# **Transportation Impact Study Addendum**

## **PROPOSED INDUSTRIAL DEVELOPMENT**

3054 Homestead Drive, 9174 & 9166 Airport Road W  
HAMILTON, ONTARIO

## CITY OF HAMILTON COMMENTS

**Figure 6 – Existing Traffic Volumes (2022 TMC – Balanced)**

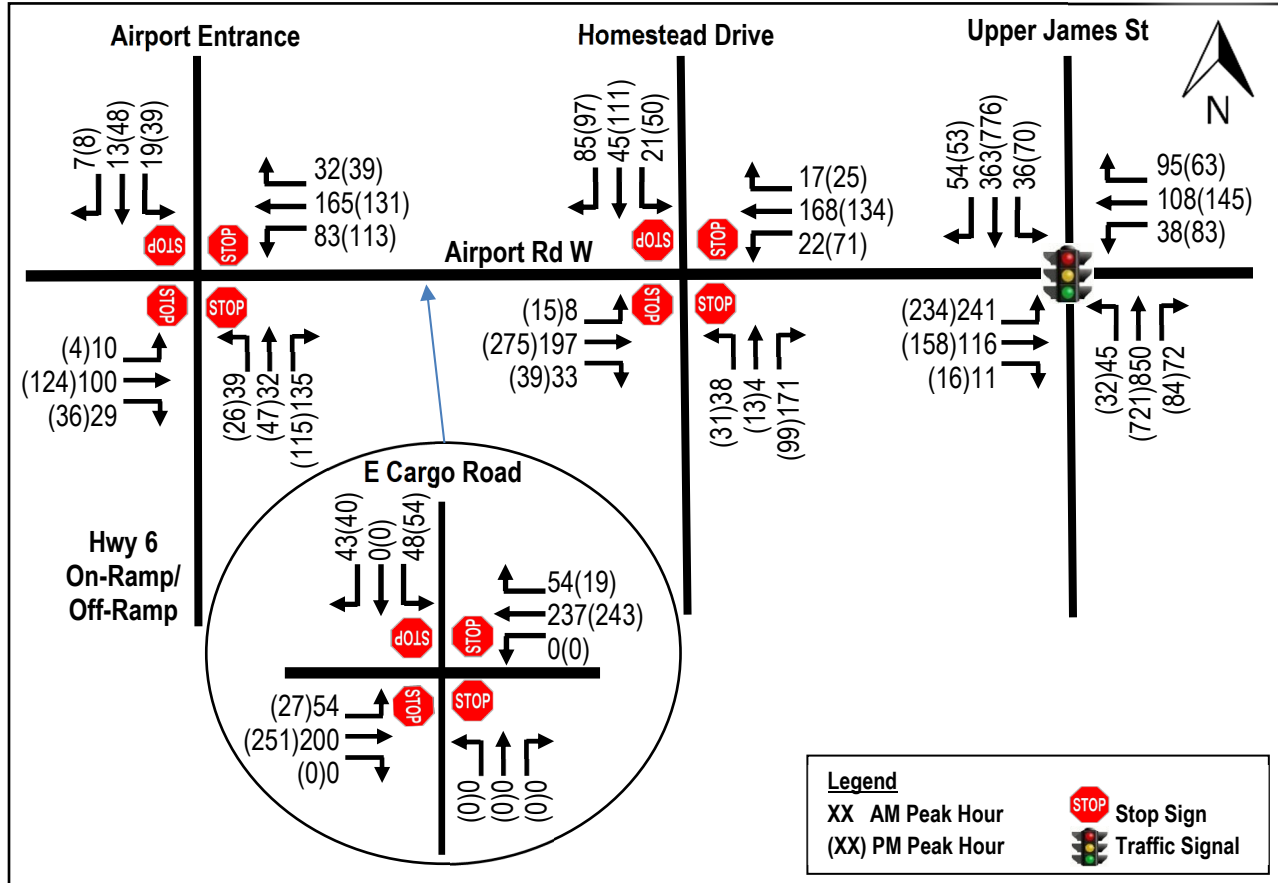
2. Figure 6 – Existing Traffic Volumes, the provided existing traffic volumes are dated from 2019, a 2% growth rate should be applied to bring the volumes up to the expected 2022 volumes.

**Response:** As per comment 3 below, Nextrans has updated the traffic turning movement counts on Wednesday June 15, 2022. It should be noted that there are no pandemic related restrictions or major construction during this time that may impact the turning movement counts. Therefore, the turning movement counts are considered normal and capture all new developments in the area.
